CITY PLAN COMMISSION

FILE NUMBER: S223-225

REQUEST: An application to replat a 1.4244-acre tract of land containing all of Lots 1 through 4, 7 and part of Lots 8 through 11 in City Block 13/1159 and a portion of 15-foot abandoned alley to create one lot on property located between Pennsylvania Avenue and Peabody Avenue, east of Harwood Street.

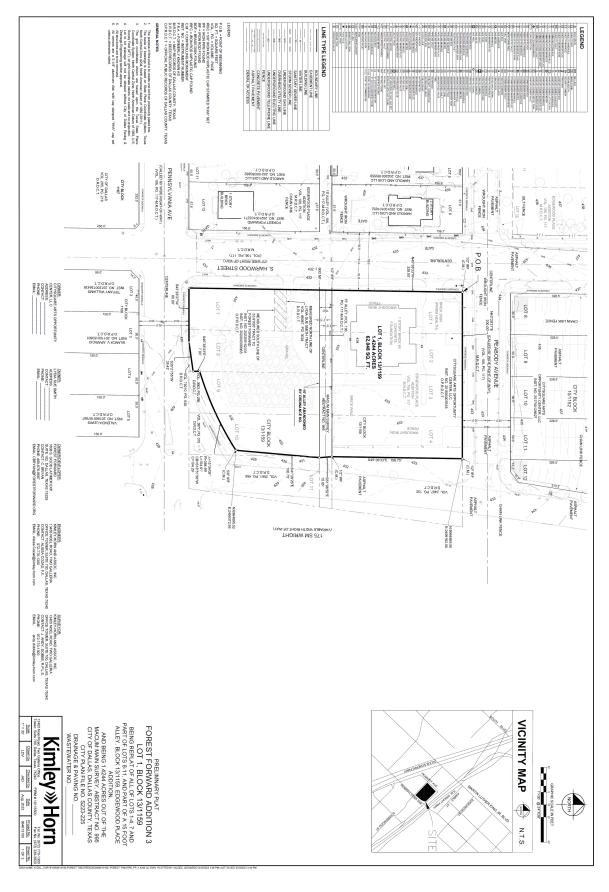
- 15. On the final plat, dedicate a minimum 5-foot by 5-foot corner clip (via fee simple or street easement) at the intersection of Peabody Avenue & Harwood Street. Section 51A 8.602(d)(1)
- 16. On the final plat, dedicate a minimum 5-foot by 5-foot corner clip (via fee simple or street easement) at the intersection of Pennsylvania Avenue & Harwood Street. Section 51A 8.602(d)(1)
- 17. On the final plat, dedicate a minimum 5-foot by 5-foot corner clip (via fee simple or street easement) at the intersection of Peabody Avenue & Service Road. Section 51A 8.602(d)(1)
- 18. A larger corner clip may be requested during engineering plan and traffic review to accommodate an adequate turning radius, or to maintain public/traffic appurtenances, within the area of the corner clip. *Section 51A 8.602(d)(1), 51A 8.608(a)*

- 27. Prior to the final plat, please fence in right-of-way on Peabody Avenue and S. Please show the alley abandonment on the plat as follows: Abandonment authorized by Ordinance No._____, recorded as Inst. Nos. (Cert. ORD No._____). Utility Easements retained.
- 28. On the final plat, change "Pennsylvania Ave" to "Pennsylvania Avenue"/ Change "S Hardwood Street" to "Harwood ST/ Change "175 SM Wright Freeway" to "Central Expressway (A.K.A.S.M. Wright Freeway)".
- 29. On the final plat, identify the property as Lots 1A in City Block 13/1159. Ordinance 1A, Page 131 pages 131-148, Section 2 (passed August 13, 1872).
